# Determination 2024/014

**Compliance of a stormwater tank near a property boundary with Building Code clauses concerning fire affecting other areas**

**Future lot 26, Border Road, Henderson, Auckland**

**Figure 1: Site plan (not to scale)**

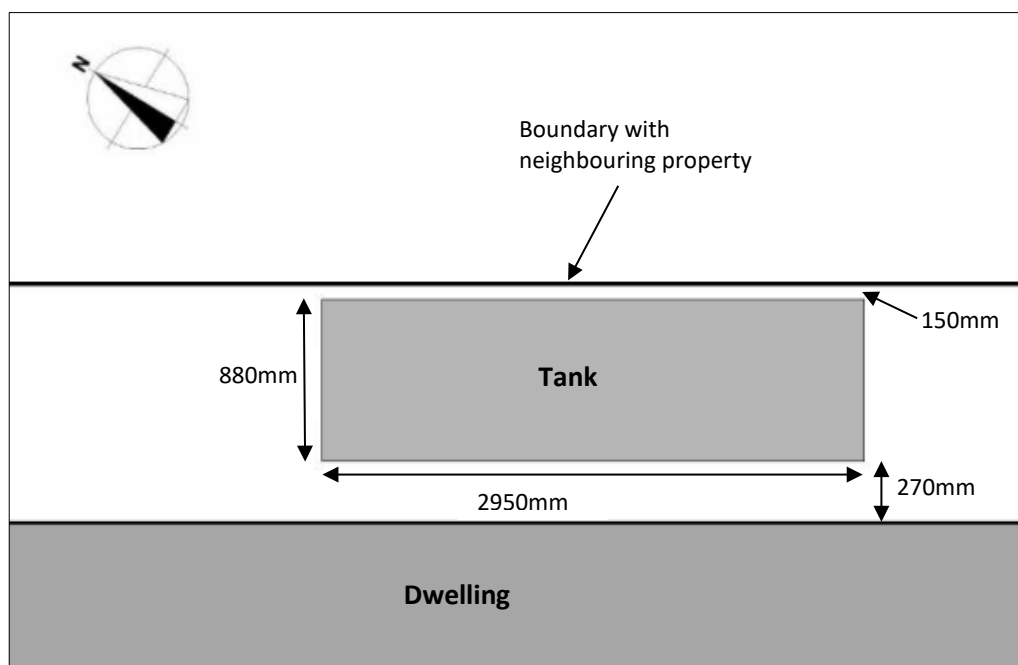
Please justify compliance with NZ Building Code clauses C3.6 and 3.7. The storm water detention tank is shown against the boundary on sheet 101. Your nominated means of compliance requires these to be fire rated if they are within 1 m of the boundary. Please provide calculations or evidence showing the ignition and heat output requirements of the building code will be [met] in the current location.

4.25. The tank is located 150mm from the relevant boundary, being the boundary of the property with the neighbouring property. This is closer than 1m.

4.27. The tank, being a stormwater tank, is primarily intended to hold and store water (and air), which does not require protection against the outdoor environment. Therefore, the tank does not have 'external walls' as that term is defined.

5.1. In accordance with section 188 of the Building Act 2004, I determine the stormwater tank near the boundary of the property is not required to comply with clauses C3.6 and C3.7 of Clause C3 *Fire affecting areas beyond the fire source*.

**Figure 2: Section through tank (not to scale)**

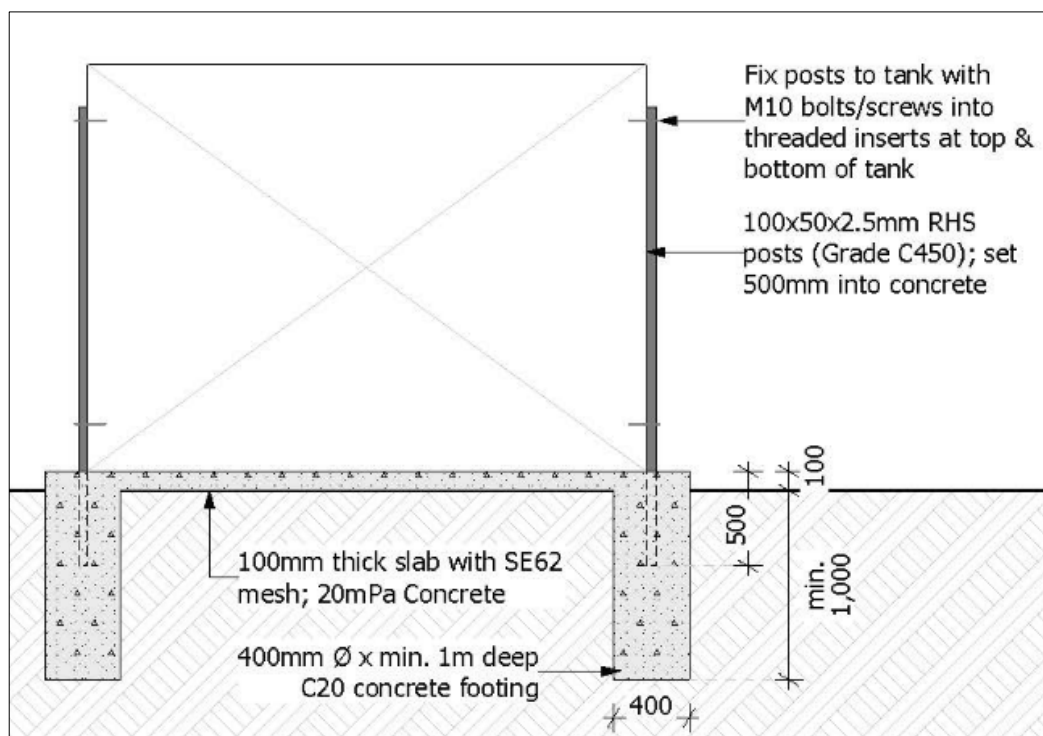
- 2.3. The plastic component of the tank is fixed between two steel posts at each end, with the posts set into a 100mm thick concrete slab on the ground with 1m

concrete footings (refer to Figure 2). Water enters the plastic tank via a pipe at the top which comes from the dwelling's downpipes and exits via a pipe connected to the main stormwater network. There is also an outlet tap at the base of the plastic tank.
